Mods to make SRM-125 respond only
to 4K window:

IK - 8K STATIC EPROM MODULE

SRM-125 12-31-75

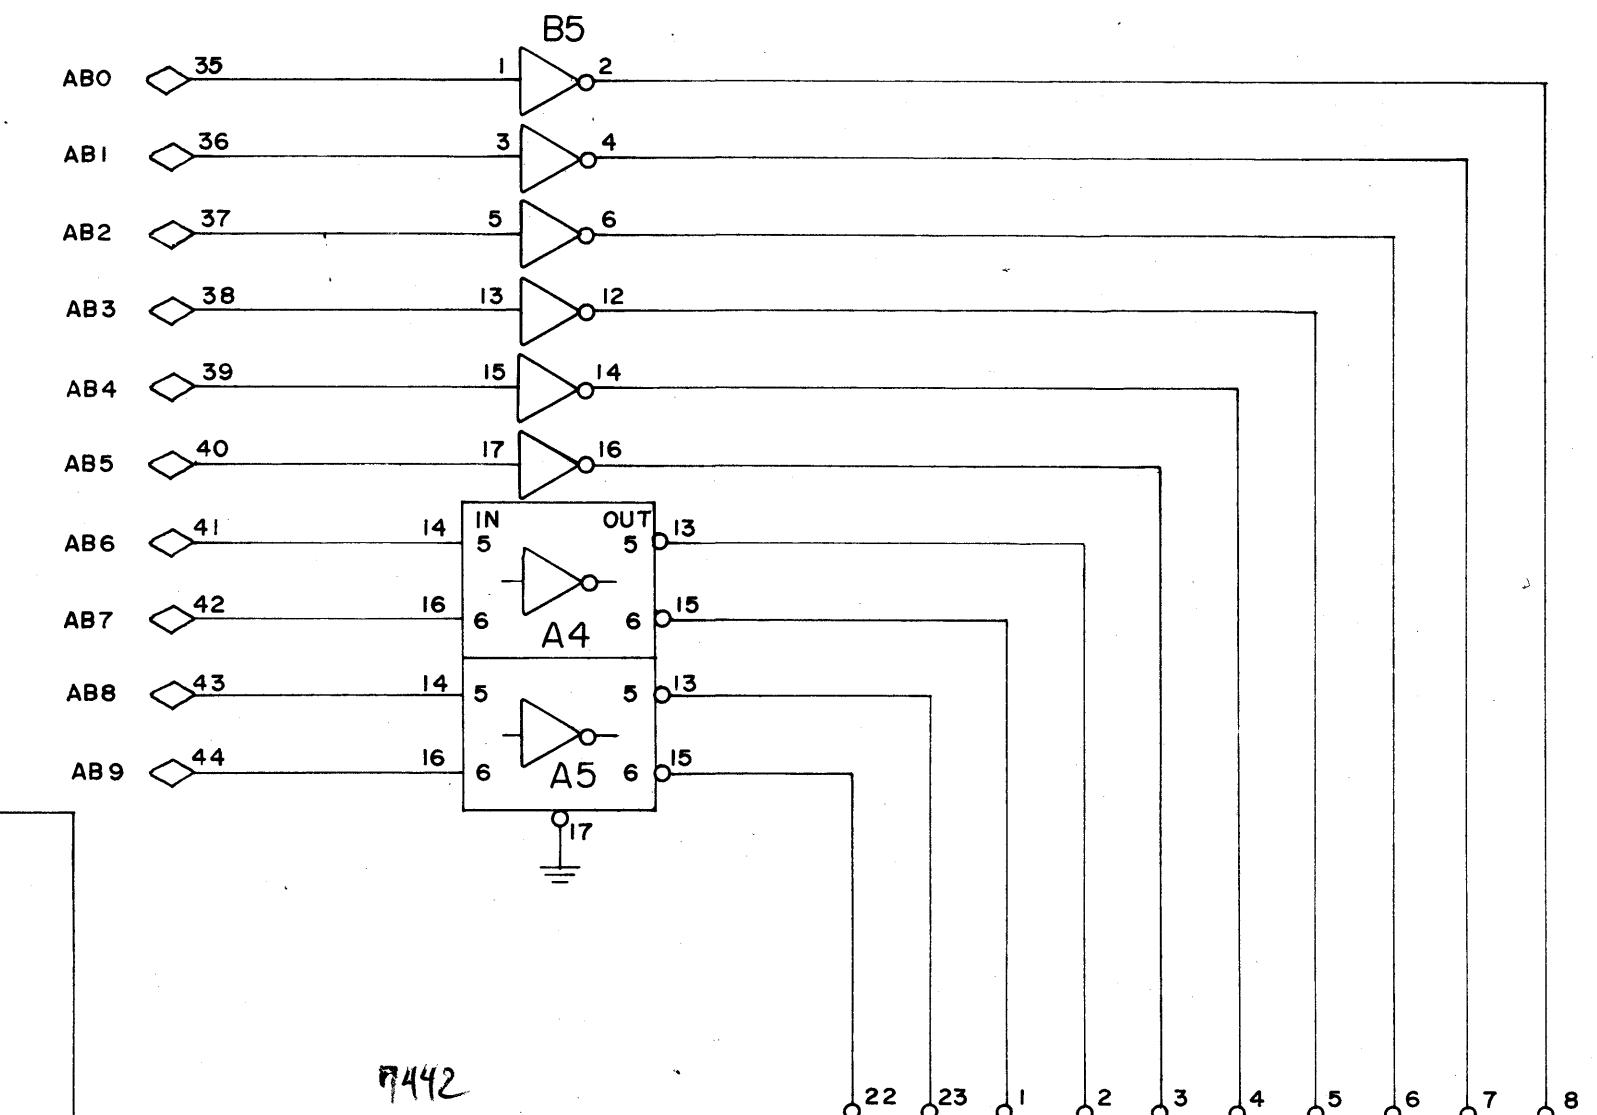
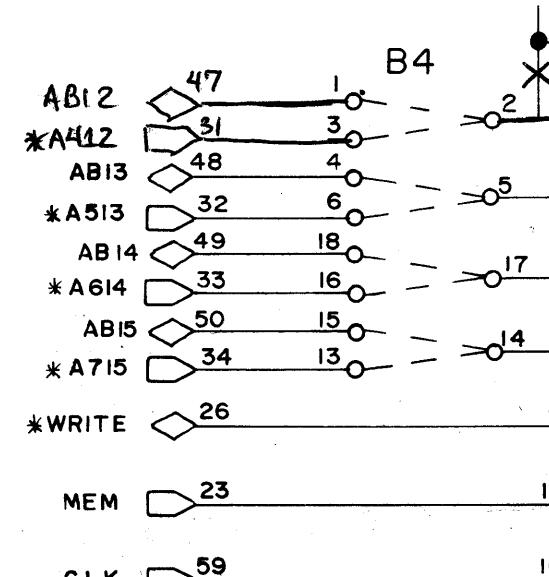
Remove C4-2 to C4-1

Add C4-2 to B4-2

Add B4-1 to BUS-47 (AB12)

Add B4-3 to BUS-31 (*A412)
